March 7, 2013

Re: Tampa Electric Company - Big Bend Station

Request for Additional Information

Fuel Igniter Replacements File No. 0570039-062-AC Facility ID No. 0570039

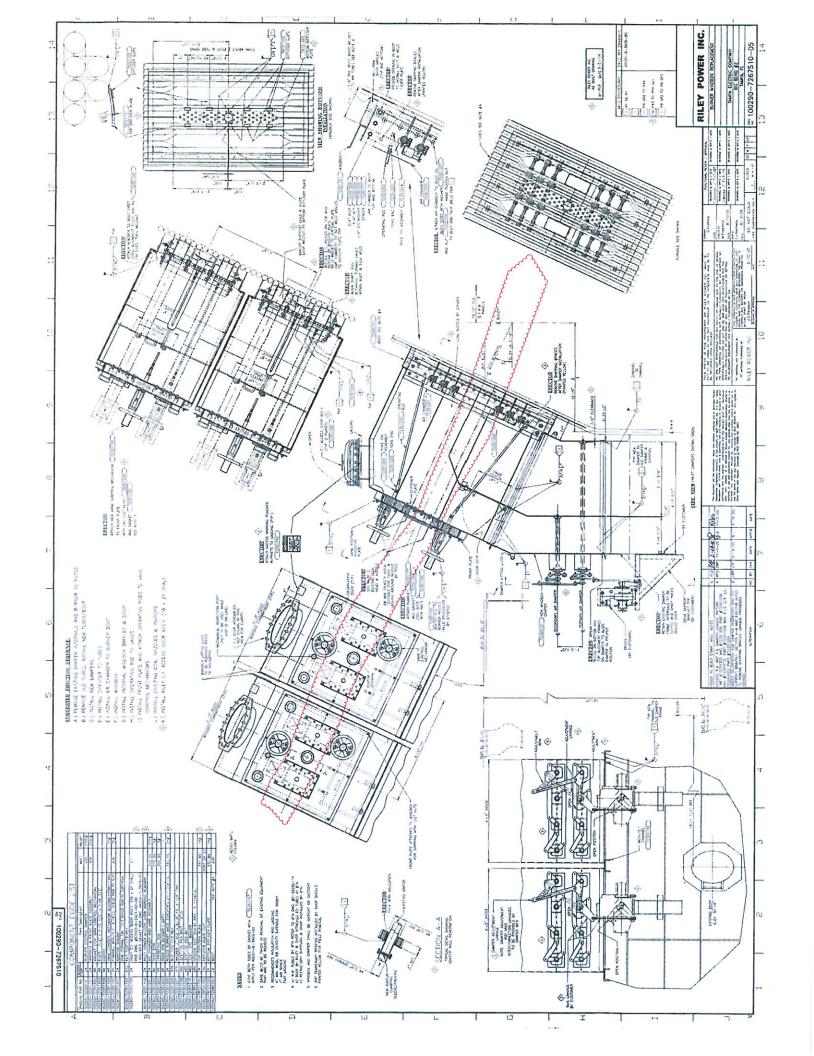
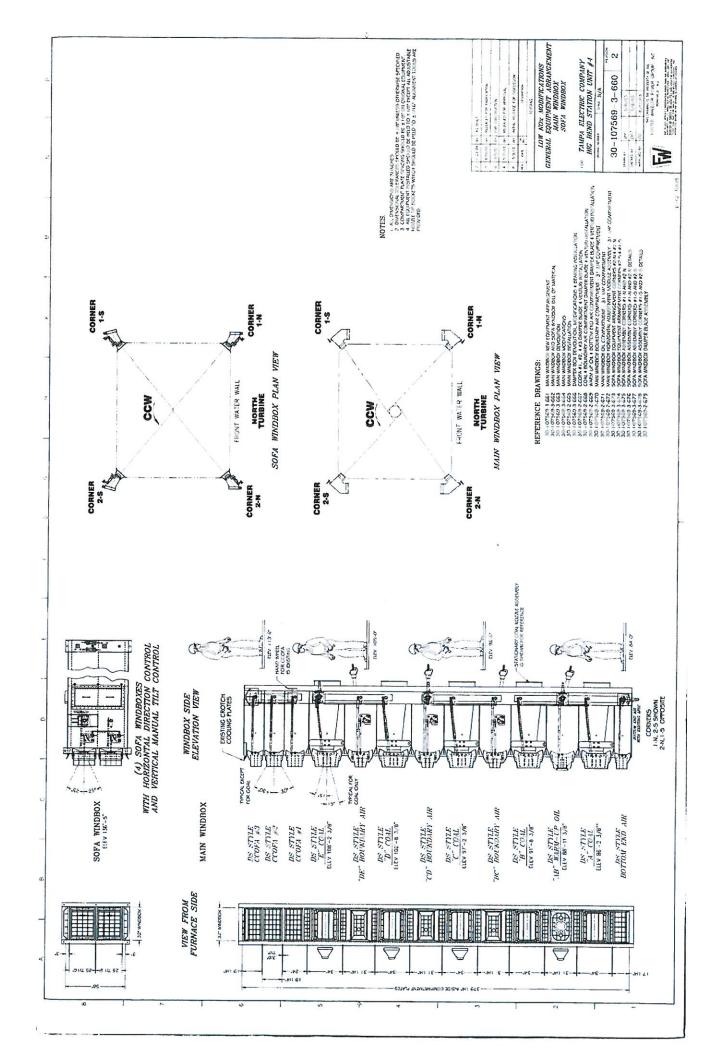
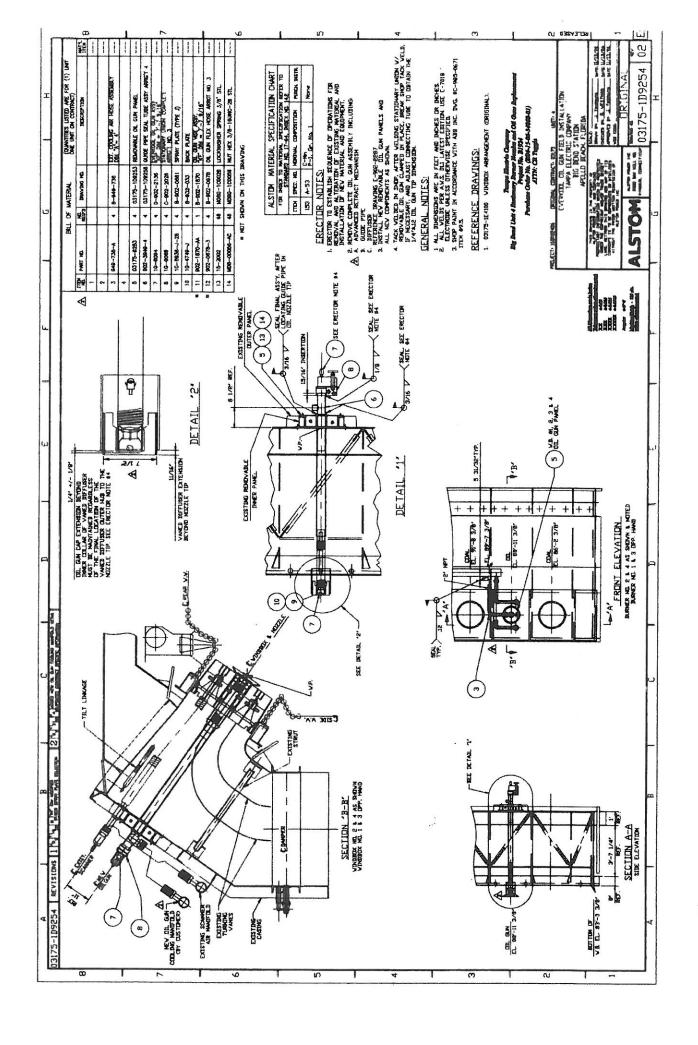
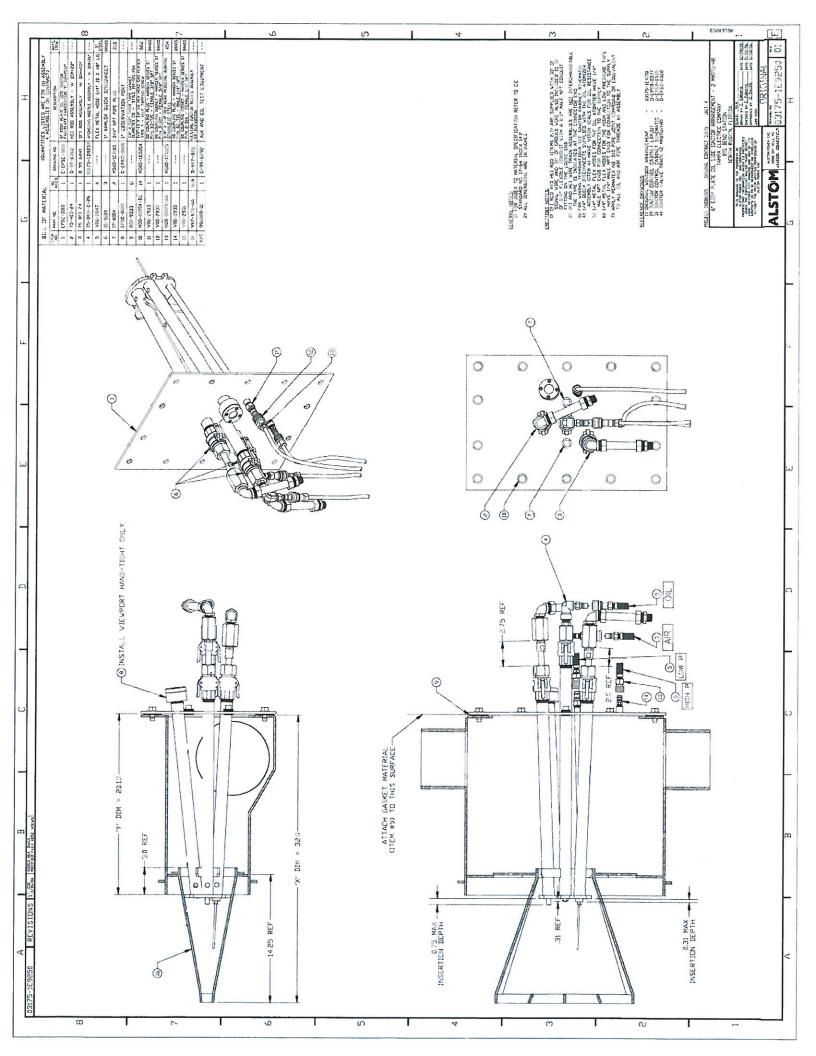
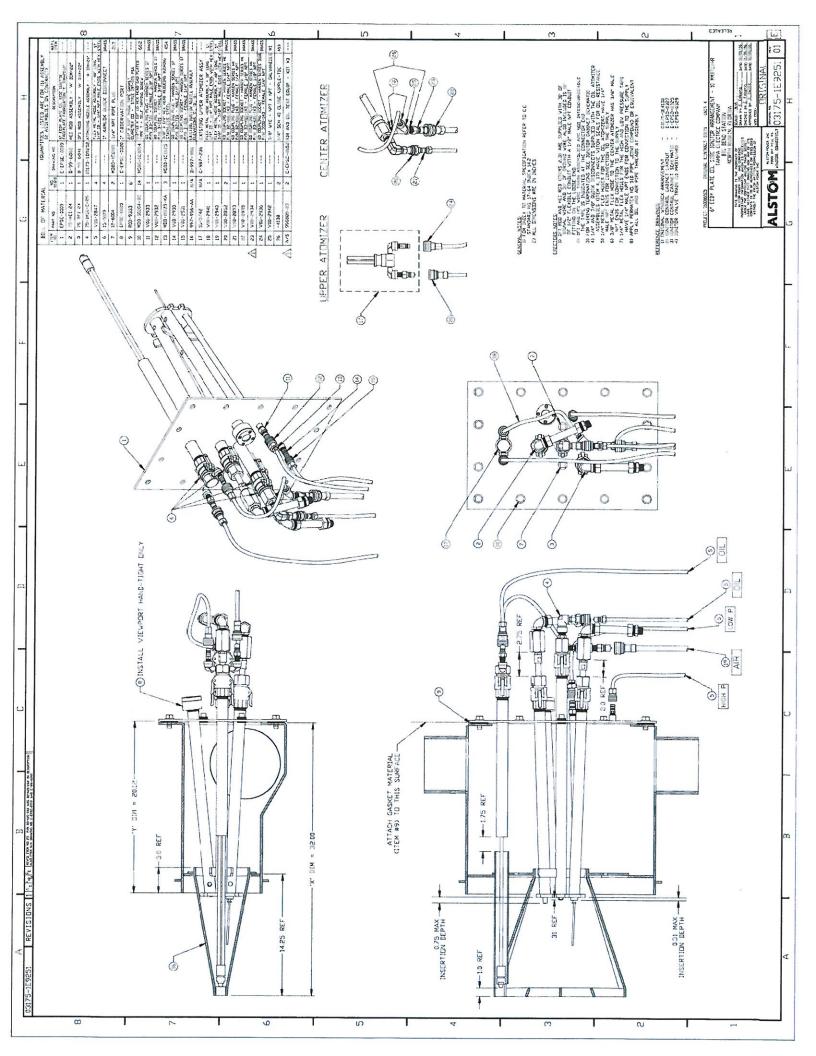
The application requests adding natural gas igniters. Please describe this project in further detail including a description of how these igniters will be integrated with existing igniters (will these new igniters be operated together with existing oil igniters or separately?) and the physical and operational changes associated with this project. Provide this information for each boiler along with a layout of the new igniters in each boiler so that the location and number of new igniters is shown.

The existing ignition systems on Units 1 to 3 consist of 24, 4-inch fuel oil igniters. The igniters are Hamworthy Peabody type (Model OE-HE) rated at a heat input rating of 15 mmBtu per hour. Each igniter is installed within each windbox on 4 feet 6-inch centers on the front and back walls of each boiler at 61.0 feet El. Each igniter is installed in a 4-5/8-inch guide tube that is orientated into the boiler at a fixed location of 25° below elevation. The drawings of the Units 1 to 3 ignition systems are shown attached.

Unit 4 consists of 5 coal feeding elevations (A, B, C, D, and E). The existing ignition system on Unit 4 consists of varying sizes and locations of igniters. Twelve (12) fuel oil igniters (6-inch Limelight eddy plate type) are rated at a heat input of 10 mmBtu per hour. Four (4) igniters are installed at each corner and wind box at coal feeding elevations C (97 feet 2-3/8 inches El.), D (102 feet 8-3/8 inches El.), and E (108 feet 2-3/8 inches El.) for a total of 12 igniters. Four (4) additional fuel oil igniters rated at heat input of 244 mmBtu per hour are located between coal feeding elevation A-B (88 feet 11-3/8 inches El.). These warm up igniters are designed to heat the boiler during startup. Each warm up igniter is equipped with a secondary igniter to startup each warm up igniter. Each secondary igniter is rated at 2 mmBtu per hour. The igniters are currently designed to be tilted ±30°. However, the igniters are typically oriented at 0° (neutral) during operation. The drawings and locations of the Unit 4 ignition system are shown attached.
